**Re: Response to Comments – Comment Letter Pre & Post Closure Groundwater Sampling Plan RTC (July 6, 2022)
Hess Corporation Former Port Reading Complex (HC-PR)
750 Cliff Road
Woodbridge, Middlesex County, New Jersey
NJDEP PI# 006148
ISRA Case No. E20130449
EPA ID No. NJD045445483**

Earth Systems, Inc. (Earth Systems) has prepared this letter on behalf of Hess Corporation (Hess) in response to the July 6, 2022 comment letter regarding the Pre & Post Closure Groundwater Sampling Plan Response to Comments (RTC) submitted by Hess and Earth Systems on April 22, 2022.

NJDEP Comments & Earth Systems/Hess Responses

April 1985 AWARE Inc. Drawings
(Comment 3)

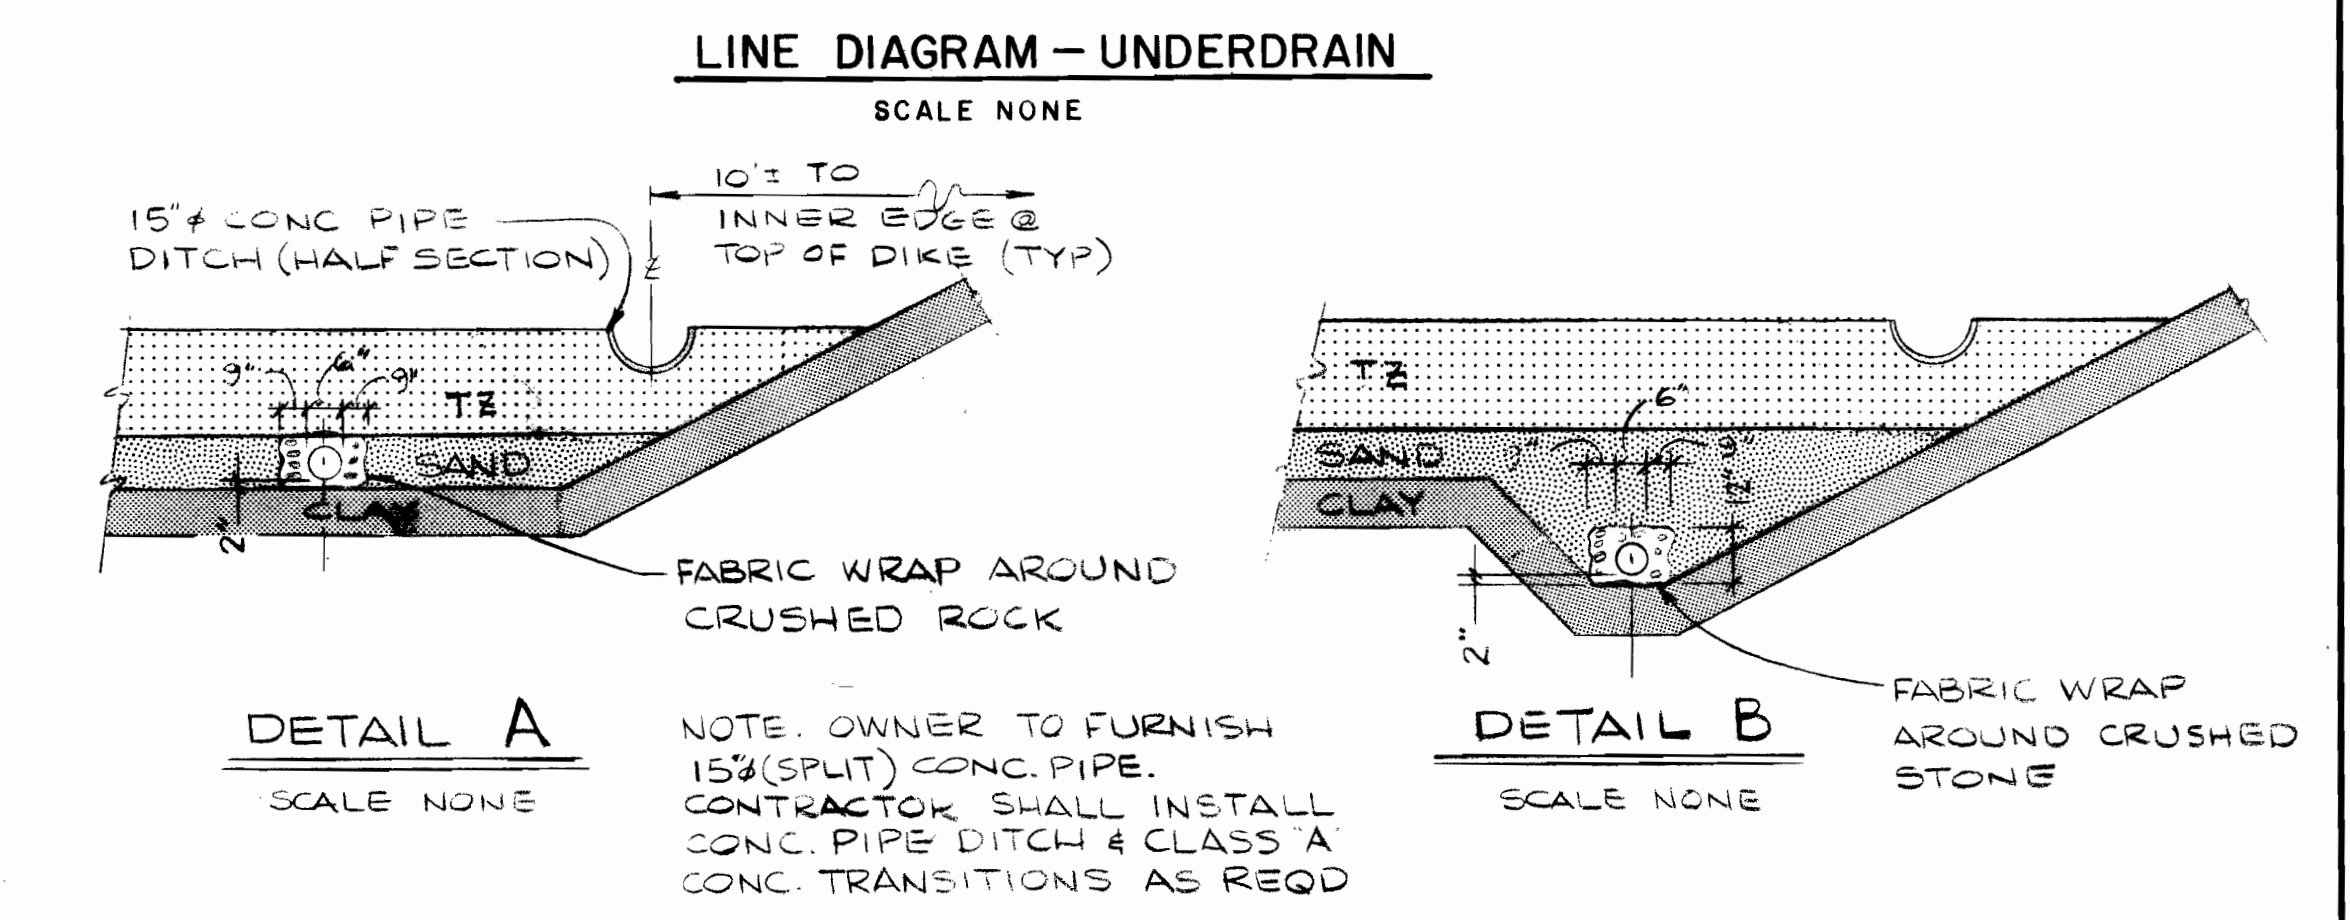
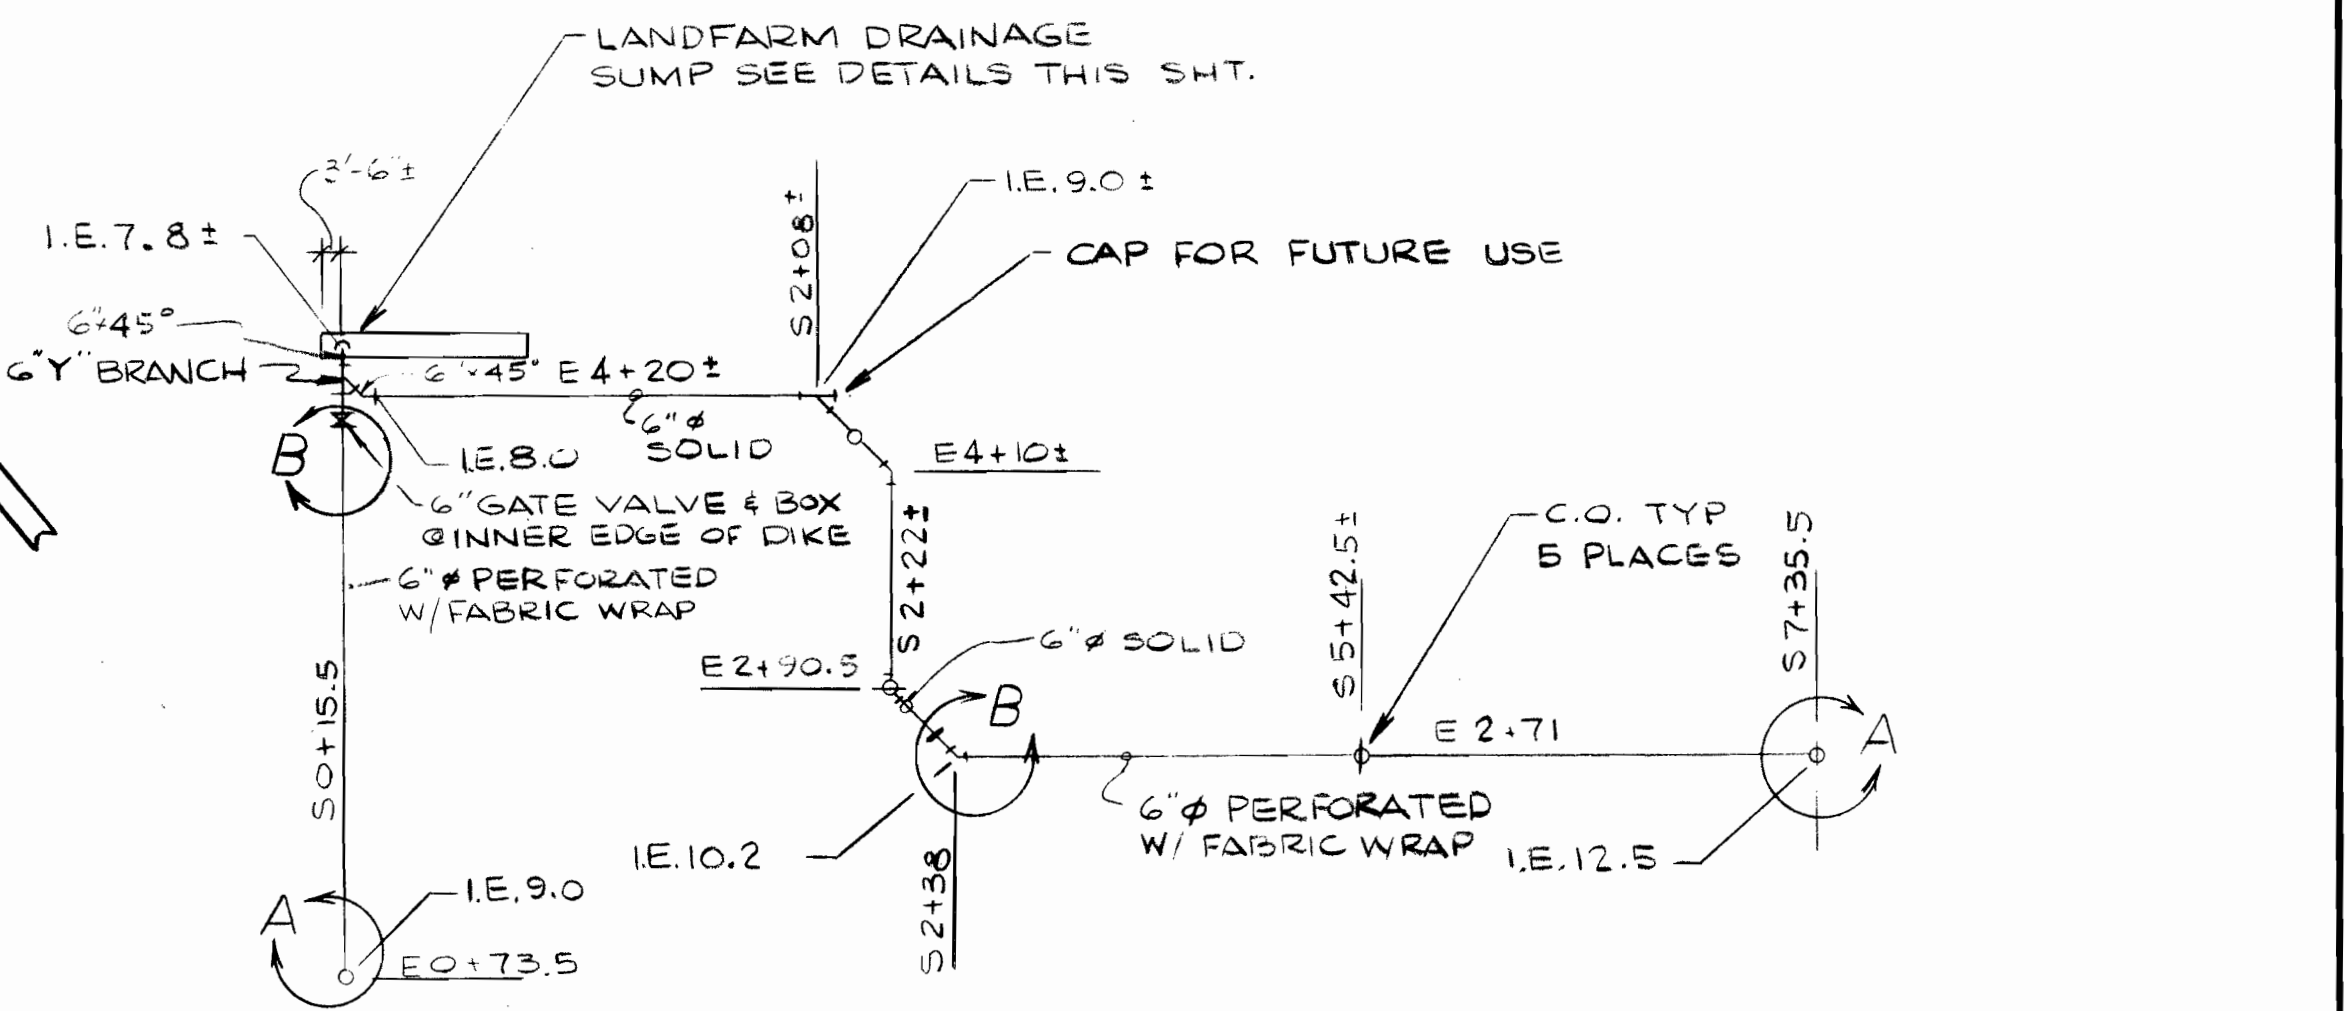
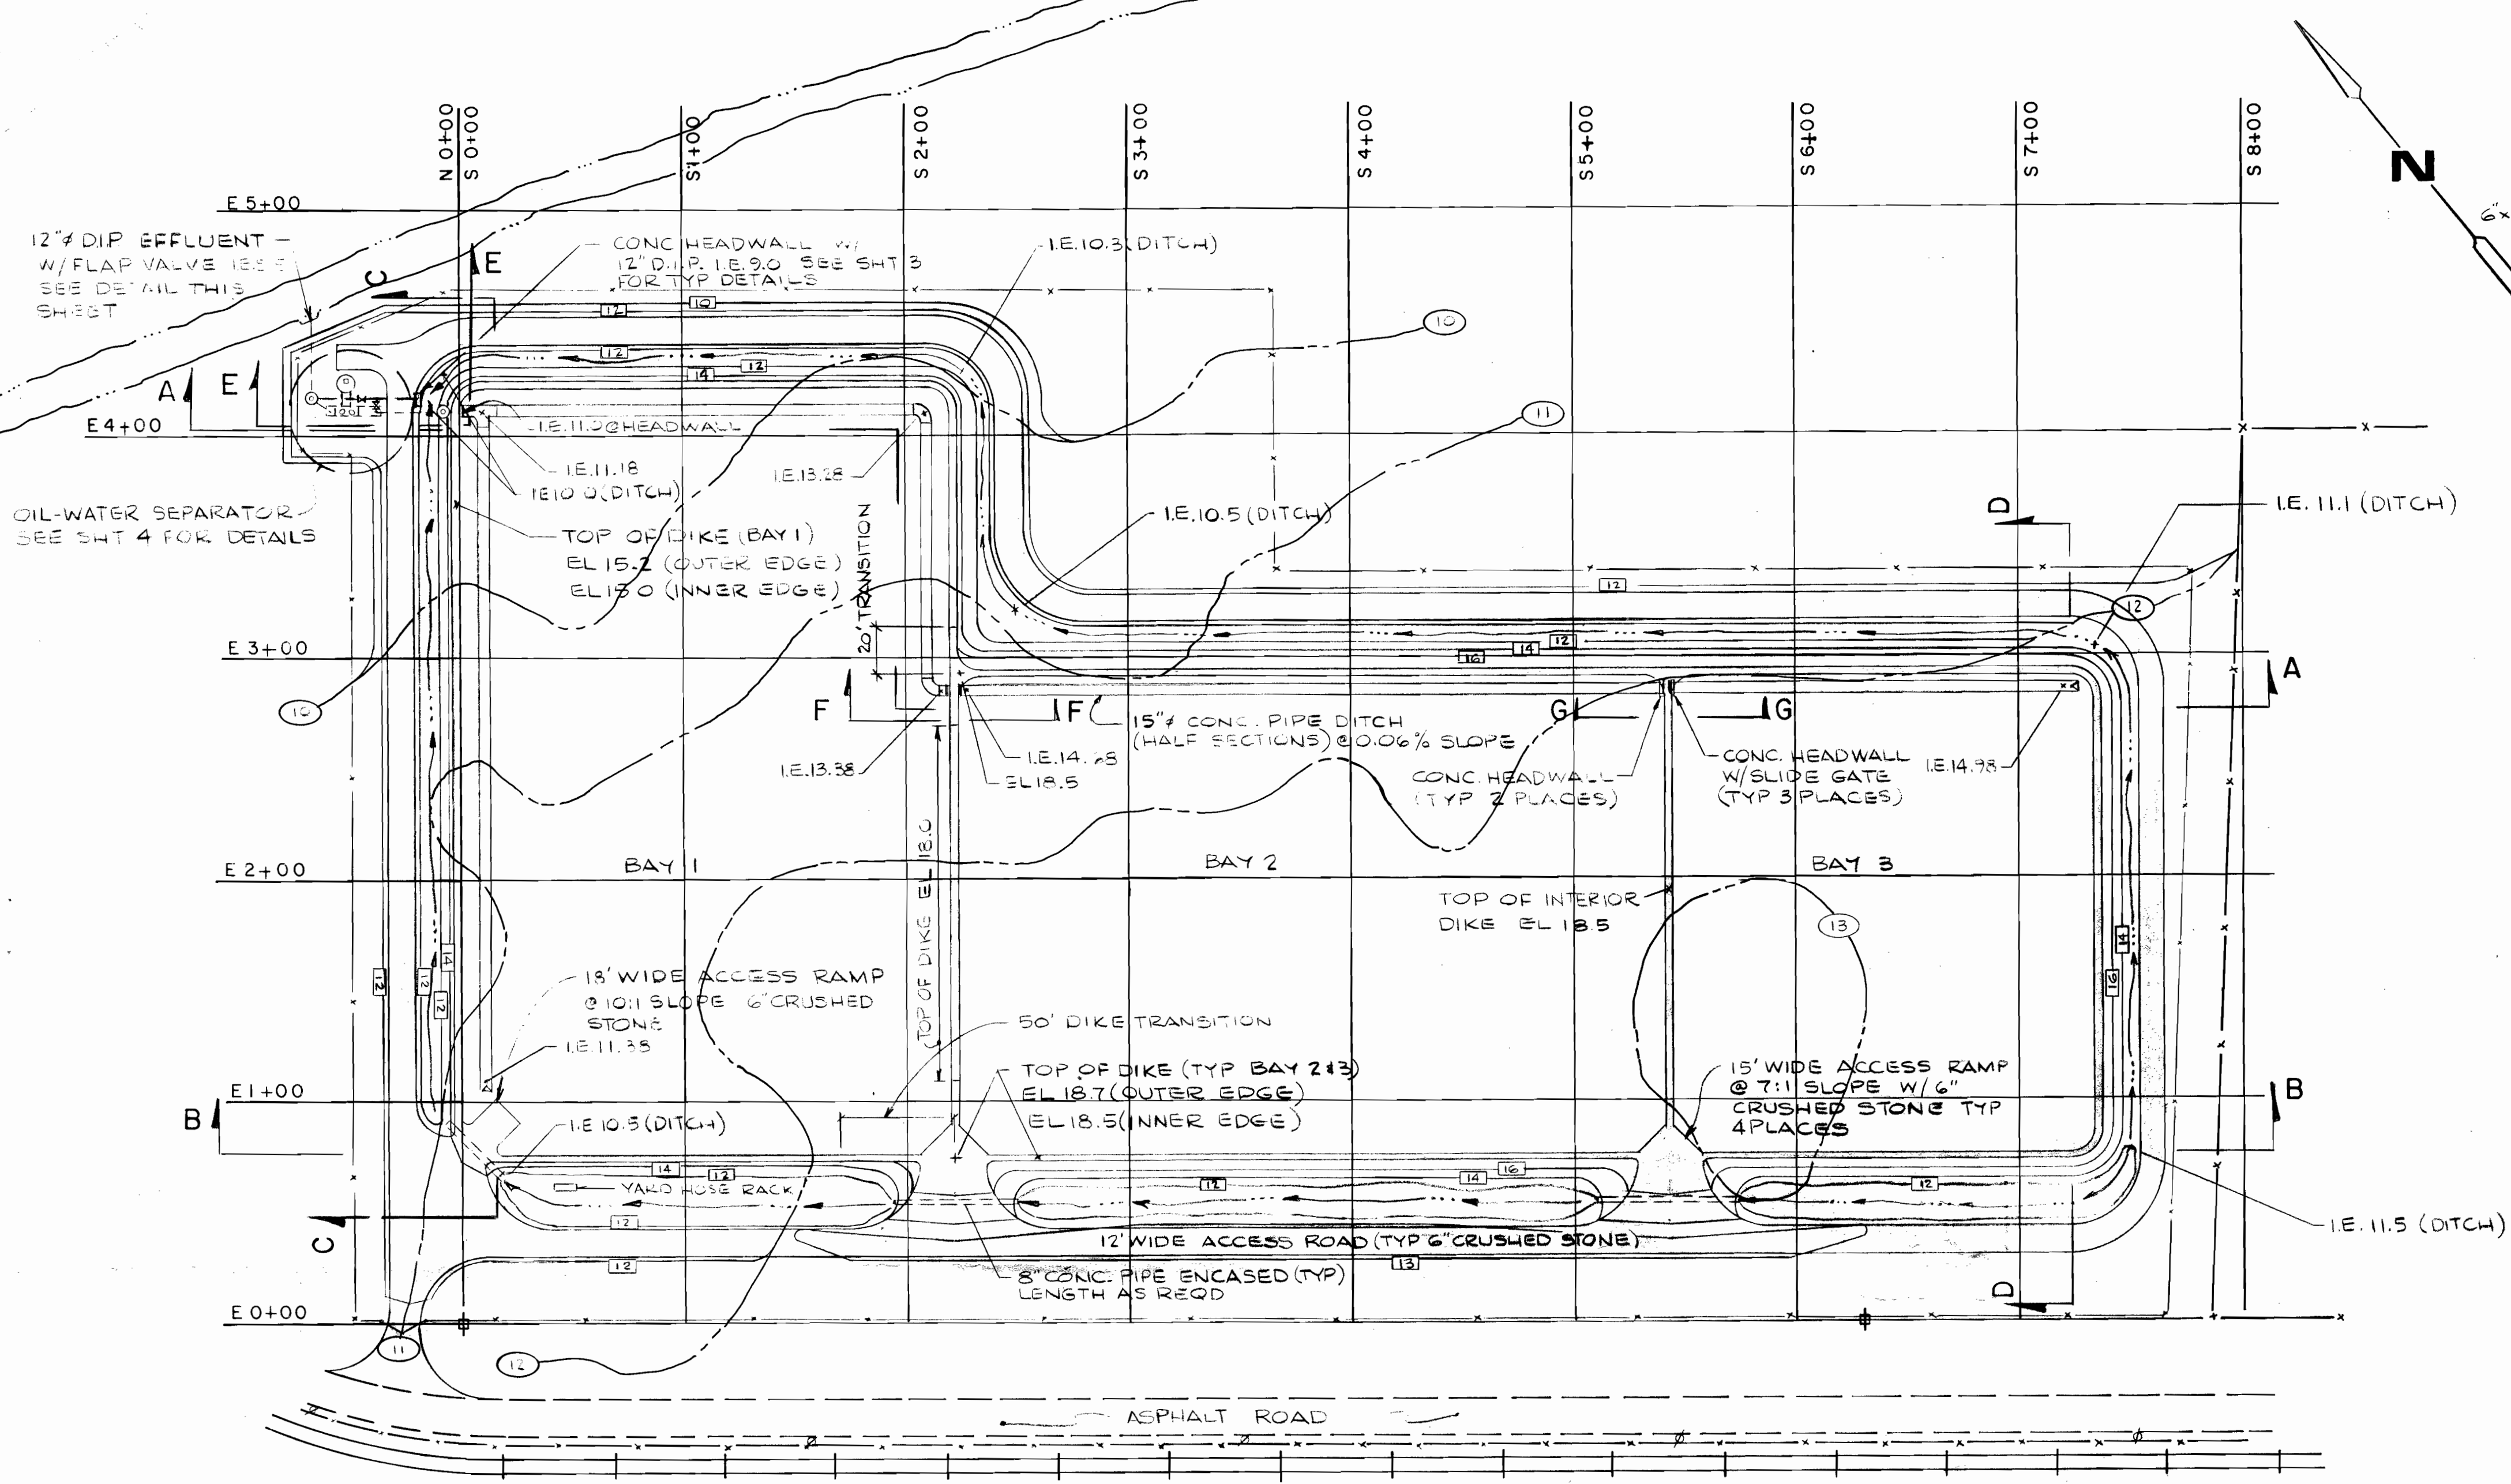
Existing well records/logs were provided as part of the response. Aware Corporation 1985 design drawings (provided with the November 1, 2019 response to comments on the 100% cap design for the No. 1 Landfarm) were not included with the response for future reference.

The AWARE 1985 design drawings will need to be included with the final No. 1 Landfarm GWSP. They should also be included with the RAR – Construction Complete Report for the No. 1 Landfarm capping.

The AWARE 1985 drawings have been included with this response.
